_								CR-Form-v7
CHANGE REQUEST								
*	33.2	220 CR	CRNum	≋ rev	- #	Current vers	ion: 6.1.0	¥
For <u>HELP</u> on using this form, see bottom of this page or look at the pop-up text over the # symbols.								
Proposed change affects: UICC apps# X ME Radio Access Network Core Network								
Title:	€ GBA	U. Ks. ex	t not stored on	UICC

Summary of change: In GBA_U, Ks_ext is given to the ME and not stored on the UICC.								
Consequences if	H	Ks_ext is	stored both on	the ME ar	d on the l	JICC.		
not approved:								
Olassa a effectada	0.0	F04 F0	2					
Clauses affected:	*	5.2.1, 5.3.	2					
	Ţ.	YN						
Other specs	æ		r core specific	ations	*			
affected:	"		specifications					
			1 Specifications	S				
	<u></u>							
Other comments:	 #

Figure 5.1: The bootstrapping procedure with UICC-based enhancements

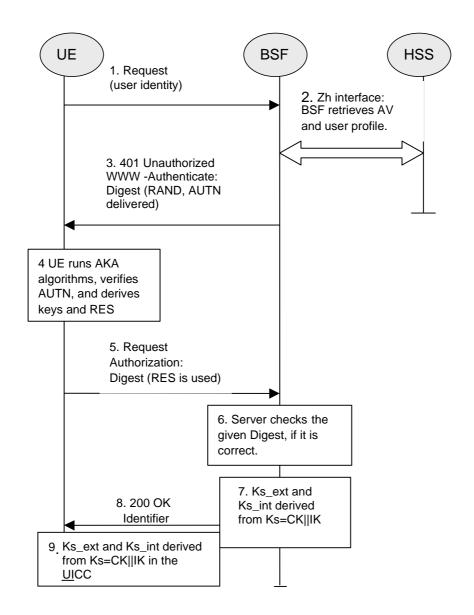
- 5. The UICC checks if a GBA_U-AV was received as specified in step 2 of this clause. If this is not the case, the UICC transfers RES, CK and IK to the ME, and the ME proceeds according to the procedures specified in section 4 of this document, without involving the UICC any further. If a GBA_U-AV was received, the UICC then applies a suitable key derivation function h1 to Ks, which is the concatenation of CK and IK, and possibly further h1-key derivation parameters to obtain two keys, Ks_ext and Ks_int, each of length 128 bit, i.e. h1(Ks,

h1 key derivation parameters) = $Ks_{ext} \parallel Ks_{int}$ (see also figure 5.2). The UICC then transfers RES (after flipping the least significant bit) and Ks_{ext} to the ME and stores Ks_{int}/ks_{ext} on the UICC.

Editors' Note: The location (whether in the UICC or in the ME) of the storage of Ks_ext is ffs.

Figure 5.2: Key derivation for GBA-aware UICC when GBA-run was triggered

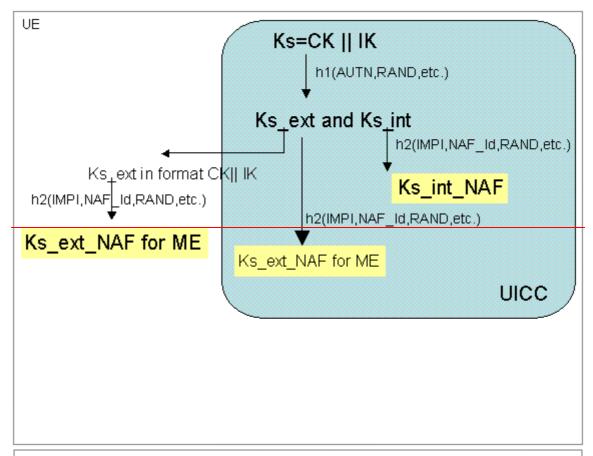
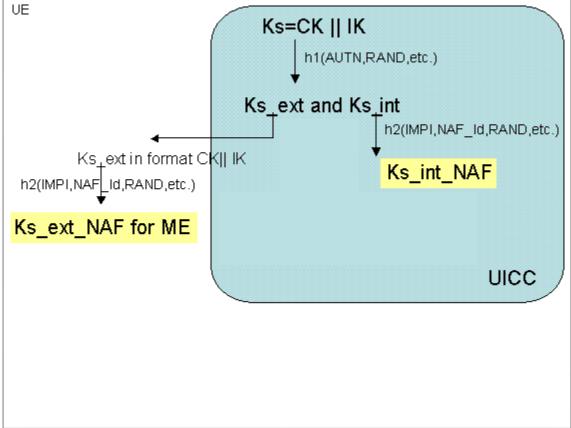
The ME, the UICC and the BSF store the keys Ks_ext and Ks_int together with the associated Transaction Identifier for further use, until the lifetime of Ks_ext and Ks_int has expired, or until the keys Ks_ext and Ks_int are updated.
